Addendum No. 2

Date: March 18, 2021
Project Name: Clark Magnet HS CTE Building
Bid No: 208-20/21
NAC No. 161-19034

END OF ADDENDUM #2 NARRATIVE OF CHANGES

ADDENDUM #2 - RFI LOG

Fig. 2-8. Shunt Trip Connection Diagram.

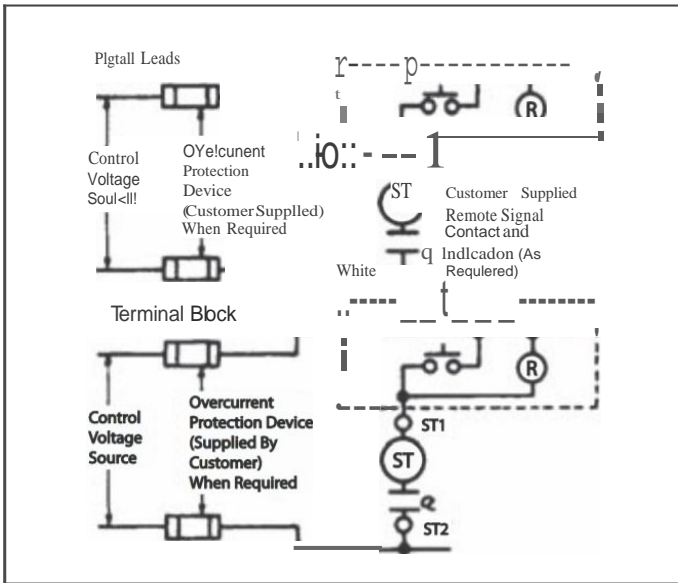
RFI 13
